Access Audit Site Report

Sea Rim State Park
19335 S Gulfway Dr
Sabine Pass, TX 77655
Accessibility Evaluation
Inspection Date: 08/16/2022
Inspectors: Tanya Scheibe

Prepared By
WT Group

**AMERICANS WITH DISABILITIES ACT COMPLIANCE INITIATIVE
PROGRAM AND POLICY REPORT
JULY 28, 2023**

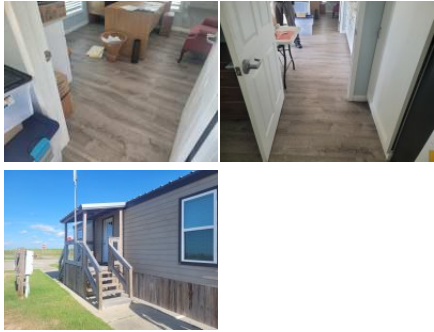
Finding Number	Area Description	Lat/Long	Finding	As Built	Recommendation	Citation	Photos	Figure
15	Headquarters Area: HQ - Public Spaces	[29.67553, -94.04353]	Stairways must have handrails on both sides. Handrails and their extensions must be between 34 inches and 38 inches above the stair nosing or ground. The top handrails shall extend a minimum of 12 inches beyond the top nosing and shall be parallel with the floor or ground surface. At the bottom of a stair flight, handrails shall extend at the slope of the stair flight for a horizontal distance at least equal to one tread depth beyond the last riser nosing. Extension shall return to a wall, guard, or the landing surface, or shall be continuous to the handrail of an adjacent stair flight. The orientation of at least one handrail, including the extension, shall be in the direction of the run of the stair and perpendicular to the direction of the stair nosing. Handrail gripping surfaces with a circular cross section shall have an outside diameter of 1-1/4 inches minimum and 2 inches maximum. Handrail gripping surfaces with a non-circular cross section shall have a perimeter dimension of 4 inches minimum and 6 1/4 inches maximum, and a cross-section dimension of 2-1/4 inches maximum. The hand grip portion of handrails shall have a smooth surface with no sharp corners. Gripping surfaces (top or sides) shall be uninterrupted by newel posts, other construction elements or obstructions. Any wall or other surface adjacent to the handrail shall be free of sharp or abrasive elements. Handrails projecting from a wall shall have a space of 1-1/2 inches minimum between the wall and the handrail.	Stairs at viewing area with ramp - lacks compliant handrails	Install handrails on both sides of stairway, mounted 34" to 38" AFF with top and bottom extensions and having a 1.25" – 2" in diameter, or a non-circular grip that has a perimeter dimension of 4"- 6.25" max with a min gap of 1.5" between handrail and wall.	2015 ABAAS Section: 505.2 2012 TAS Section: 505.2 2010 ADAS Section: 505.2

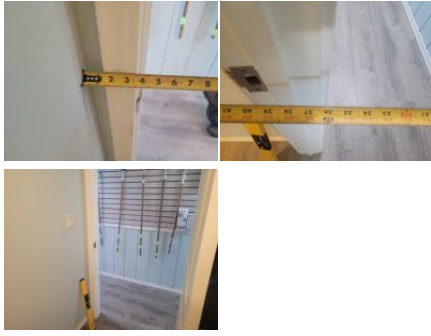
20	Headquarters Area: HQ - Public Spaces	[29.67612, -94.04395]	The transaction counter is too high. A portion of the counter surface that is 36 inches long minimum and 36 inches high maximum above the finish floor shall be provided. Knee and toe space must be provided for a forward approach. A 30 inch by 48 inch clear floor space on an accessible route must be provided for either a forward or parallel approach.	Transaction counter 42.5" above the finished floor (AFF)	Lower 36" wide segment of service counter to max 36" AFF.	2015 ABAAS Section: 904.4.2, 904.4.1 2012 TAS Section: 904.4.1, 904.4.2 2010 ADAS Section: 904.4.2, 904.4.1

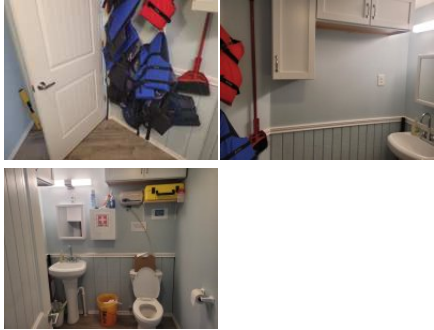
Finding Number	Area Description	Lat/Long	Finding	As Built	Recommendation	Citation	Photos	Figure
21	Headquarters Area: HQ - Public Spaces	[29.6761021 , -94.043979 6]	The ramp is too long and too high without an intermediate landing. The maximum rise for a ramp with an 8.33% slope is 30 inches. The maximum rise for any is 30 inches and the maximum length is 30 feet.	Ramp near service counter - slope of 11.2% approaching service counter	Correct slope of ramp to max 8.33%.	2015 ABAAS Section: 405.6 2012 TAS Section: 405.6 2010 ADAS Section: 405.6		
22	Headquarters Area: HQ - Public Spaces	[29.6760951 , -94.043975 6]	The ramp is missing the required landing(s). Ramps shall have landings at the top and the bottom of each ramp run. The landing clear width shall be at least as wide as the widest ramp run leading to the landing. The landing clear length shall be 60 inches long minimum.	Ramp near service counter - lacks level bottom landing - loose pavers, natural surface at bottom of ramp	Create a level landing at bottom of ramp.	2015 ABAAS Section: 405.7 2012 TAS Section: 405.7 2010 ADAS Section: 405.7

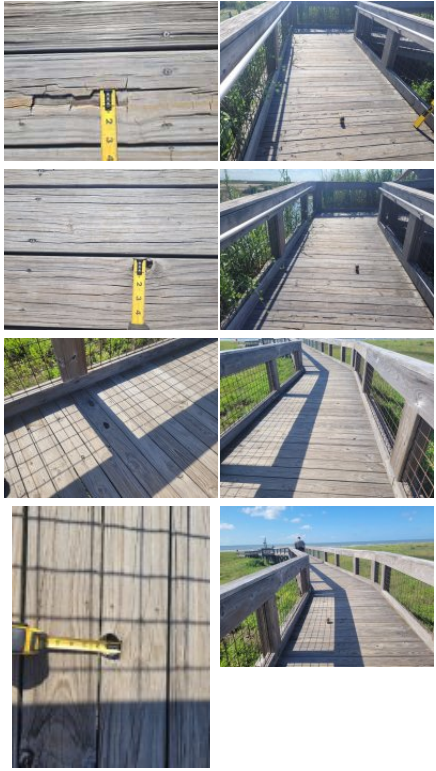
Finding Number	Area Description	Lat/Long	Finding	As Built	Recommendation	Citation	Photos	Figure
38	Piping Plover Camping Loop: Piping Plover - Parking	[29.67583, -94.04043]	Element meets all standards and requirements	Piping Plover parking meets scoping requirements - 25 standard, 2 accessible; stalls and signage comply	None	2010 ADAS Section: N/A		
39	Piping Plover Camping Loop: Piping Plover Campsite 1	[29.67553, -94.04429]	An accessible access route is not provided between elements, spaces and the facilities provided within the accessible camping unit. At least one outdoor recreation access route shall connect accessible elements, spaces and facilities provided within camping units with mobility features.	Lacks route (ORAR) to campsite amenities	Create AR with crushed and compacted stone or similar outdoor material to camp sites and one of each type of amenity.	2015 ABAAS Section: F244.5.1

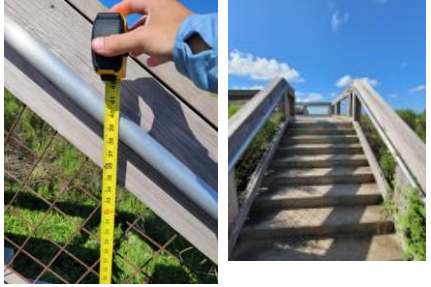
44	Piping Plover Camping Loop: Piping Plover Campsite 1	[29.67553, -94.04429]	Parking spaces and pull-up spaces for recreational vehicles shall be 20 feet (6100 mm) wide minimum. EXCEPTION: Where two adjacent parking spaces are provided for recreational vehicles, one parking space shall be permitted to be 16 feet (4880 mm) wide minimum.	Parking space is 19' 5" wide	Correct RV parking space to be 20' wide minimum; or a single spaces can be minimum 16' when two adjacent spaces are provided as a smart practice.	2015 ABAAS Section: 1012.2, 1012.2 EXCEPTION

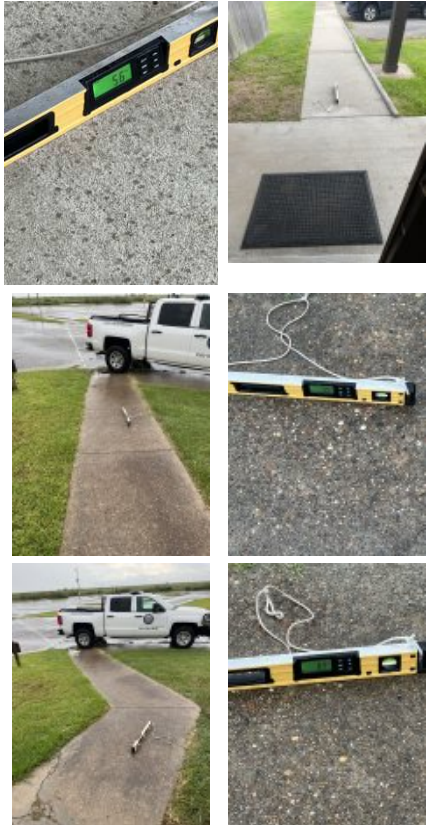
Finding Number	Area Description	Lat/Long	Finding	As Built	Recommendation	Citation	Photos	Figure
96	Blue Crab Day Use Area: Day Use - Women's Restroom	[29.675755, -94.040324 1]	The required 56 inches by 60 inches clear floor space for the water closet has been obstructed. The clear floor space around the water closet shall be 60 inches minimum measured perpendicular from the side wall and 56 inches minimum measured perpendicular from the rear wall.	Garbage can toilet clear floor space (CFS)	Relocate garbage can to provide required 60" clearance around toilet.	2015 ABAAS Section: 604.3. 2012 TAS Section: 604.3.1 2010 ADAS Section: 604.3.1		
97	Blue Crab Day Use Area: Day Use - Women's Restroom	[29.6757574, -94.040326 8]	The toilet paper is not installed within the compliant range in front of the toilet. Toilet paper dispensers shall be 7 inches minimum and 9 inches maximum in front of the water closet measured to the centerline of the dispenser. The outlet of the dispenser shall be 15 inches minimum and 48 inches maximum above the finish floor and shall not be located behind grab bars. Dispensers shall not be of a type that controls delivery or that does not allow continuous paper flow. There shall be a clearance of 1 1/2 inches minimum below the grab bar.	Centerline of TP dispenser bar is 11.5" from toilet	Remount toilet paper dispenser max 7" to 9" from front of toilet, 15" to 48" AFF and min 12" above or 1.5" below grab bar.	2015 ABAAS Section: 604.7 2012 TAS Section: 604.7 2010 ADAS Section: 604.7

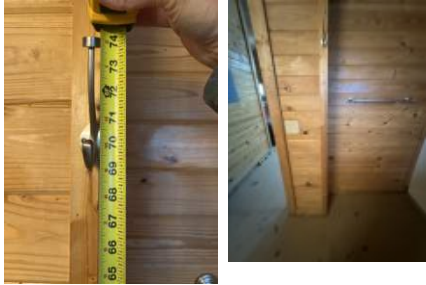
Finding Number	Area Description	Lat/Long	Finding	As Built	Recommendation	Citation	Photos	Figure
119	Marsh Unit: Marsh - Cabin	[29.6841392 , -94.032756 3]	The top rim of the sink is too high. All lavatories/sinks that are designated to be accessible shall be a minimum 17 inches in horizontal depth and mounted with the rim or counter edge no higher than 34 inches above the finished floor.	Rim of sink at 36" above the finished floor (AFF)	Lower sinks to max 34" above the finished floor (AFF) to front of rim.	2015 ABAAS Section: 606.3 2012 TAS Section: 606.3 2010 ADAS Section: 606.3		
120	Marsh Unit: Marsh - Cabin	[29.6841357 , -94.032768 4]	Knee and toe space has not been provided at the sink. Kitchen sinks must be provided with a clear floor space positioned for a forward approach including knee and toe clearance.	Sink lacks knee clearance - 4" clearance	Remove base cabinet.	2015 ABAAS Section: 606.2, 804.4 2012 TAS Section: 606.2, 804.4 2010 ADAS Section: 606.2, 804.4

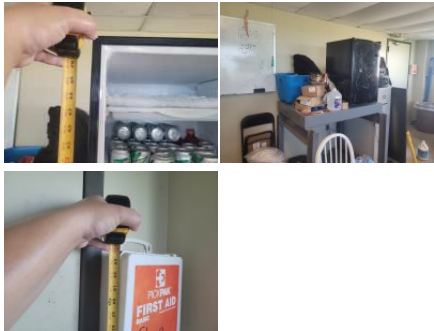
Finding Number	Area Description	Lat/Long	Finding	As Built	Recommendation	Citation	Photos	Figure
139	Marsh Unit: Marsh - Cabin	[29.6841156 , -94.032824 3]	The walkway contains abrupt vertical edges and/or variations over a 1/4 inch. 1/4 inch is the maximum vertical rise. Changes in level between 1/4 inch and 1/2 inch must be beveled at 1:2 or less. Changes in level greater than 1/2 inch must be by way of a ramp.	Two 4" steps from main parking access	Provide a ramp for access.	2012 TAS Section: 303.2, 303.3 2010 ADAS Section: 303.2, 303.3		
140	Marsh Unit: Marsh - Boat Ramp	[29.6959, -93.95592]	Element meets all standards and requirements	Boat ramps comply	None	2010 ADAS Section: N/A		
141	Marsh Unit: Marsh - Canoe/Kayak Launch	[29.684203, -94.032914 4]	Benches shall have a 36" by 48" clear ground space (CGS) positioned near the bench with one side of the space adjoining an outdoor recreation access route (ORAR) or trail, as applicable The CGS shall not overlap with the ORAR or trail or another CGS	bench has sidewalk but typically water level up over sidewalk, and then bench lacks AR	Construct firm, stable, and slip resistant pads at least 36" by 48" adjacent to 20% of benches, and locate along an AR as a smart practice.	2015 ABAAS Section: 1011.2.1
